- 5. Gruber Subdivision Ames Addition; KPB File 2024-046
Edge Survey & Design, LLC / Ames
Location: Stubblefield Drive
Kalifornsky Area**

**ITEM #5 - PRELIMINARY PLAT
GRUBER SUBDIVISION AMES ADDITION**

KPB File No.	2024-046
Plat Committee Meeting:	May 13, 2024
Applicant / Owner:	Brook and Gable Ames of Soldotna
Surveyor:	Mark Aimonetti and Jason Young / Edge Survey and Design LLC
General Location:	Stubblefield Drin Kalifornsky area / Kalifornsky APC

STAFF REPORT

GRUBER SUBDIVISION AMES ADDITION

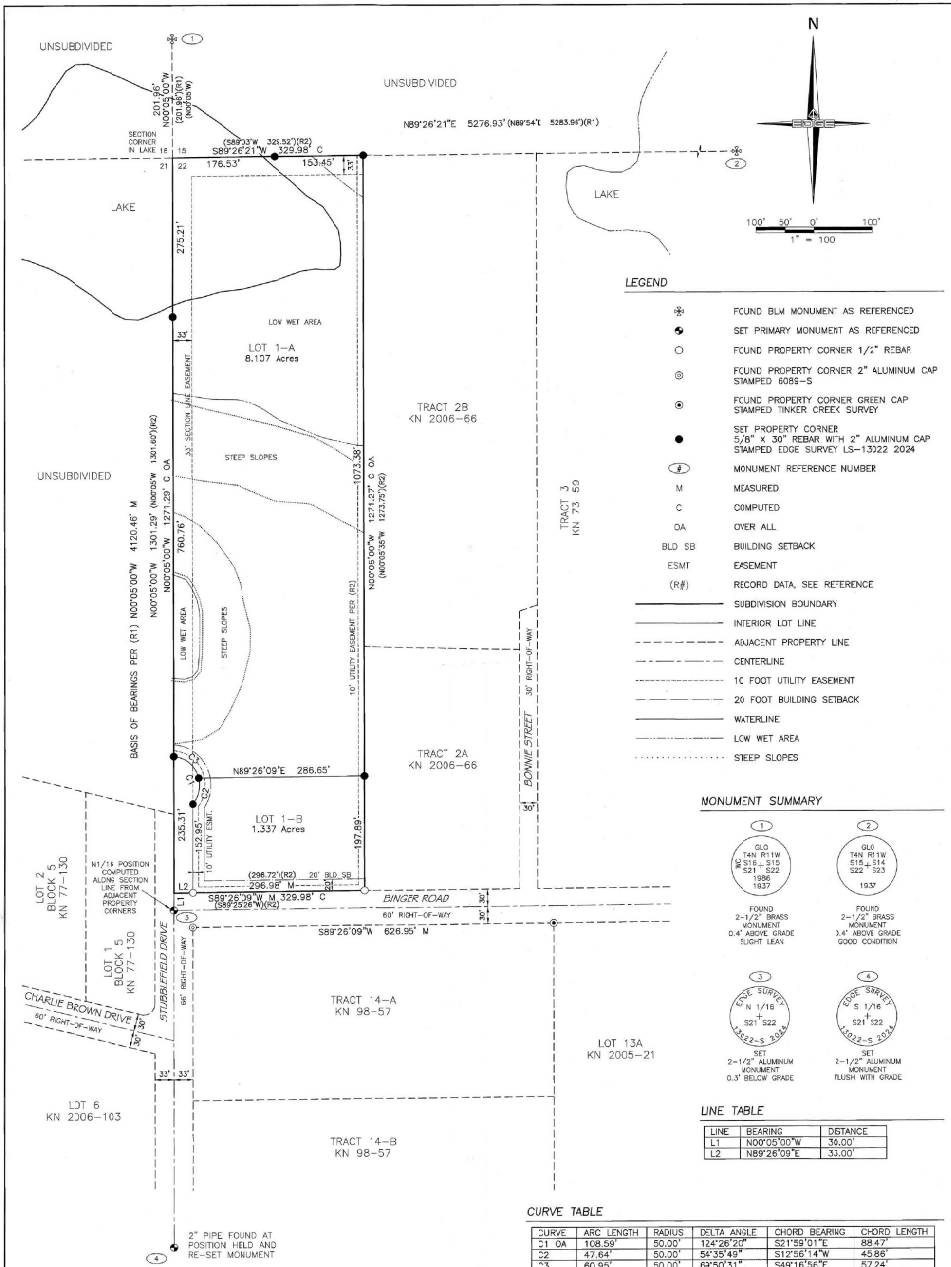
The subdivision is affected by a section line easement as shown on the drawing. The easement should be shown on both sides of the section line if they exist on both sides.

There are steep areas shown on the plat, identified as steep slopes. **Staff recommends:** the surveyor identify the

direction of slope with either an arrow or label top and toe.

There are wetlands located on the plat which are indicated as low wet areas. The River Center review did not identify any FEMA flood hazard areas or habitat protect districts. Having indicated wet areas **Staff recommendation:** Place the following note on the final plat indicating “Any person developing the property is responsible for obtaining all required local, state, and federal permits, including a U.S. Army Corps of Engineers wetland determination if applicable.”

There does not appear to be any encroachments to or from the property across lines. There is a structure located on the property to the east that appears close to the property line. The surveyor should take note of its location to the property line when doing the field work.

HEA made comments as follows: the 10’ utility easement listed as being by KN 2006-66 should be referenced to KN 72-59 on the east side of the plat.

Add KPB No 2024-046 to title block

- C. The location, width, and name of existing or platted streets and public ways, railroad rights-of-way, and other important features such as section lines or political subdivisions or municipal corporation boundaries abutting the subdivision;
Staff recommendation:
Show the temporary turnaround to the west from KN77-130

- D. A vicinity map, drawn to scale showing location of proposed subdivision, north arrow if different from plat orientation, township and range, section lines, roads, political boundaries, and prominent natural and manmade features, such as shorelines or streams;
Staff recommendation:
 Label some of the prominent lakes on the map (eg. Echo Lake, Ashana Lake, Teack Lake, Leisure Lake, Reflection Lake, etc.)

- F. The location, width and name of existing and platted streets and public ways, railroad rights-of-way, easements, and travel ways existing and proposed, within the subdivision;
Staff recommendation:
 Label the temporary turnaround shown on the parent plat

- G. The status of adjacent lands within 100 feet of the proposed subdivision boundary or the land status across from any dedicated rights-of-way that adjoin the propose subdivision boundary, including names of subdivisions, lot lines, block numbers, lot numbers, rights-of-way; or an indication that the adjacent land is not subdivided;
Staff recommendation:
 Correct the plat label number to the east

- M. Approximate locations of slopes over 20 percent in grade and if contours are shown, the areas of the contours that exceed 20 percent grade shall be clearly labeled as such;
Staff recommendation:
 Show direction of slope with an arrow or label top and toe

Add the date of May 13, 2024 to the Plat Approval
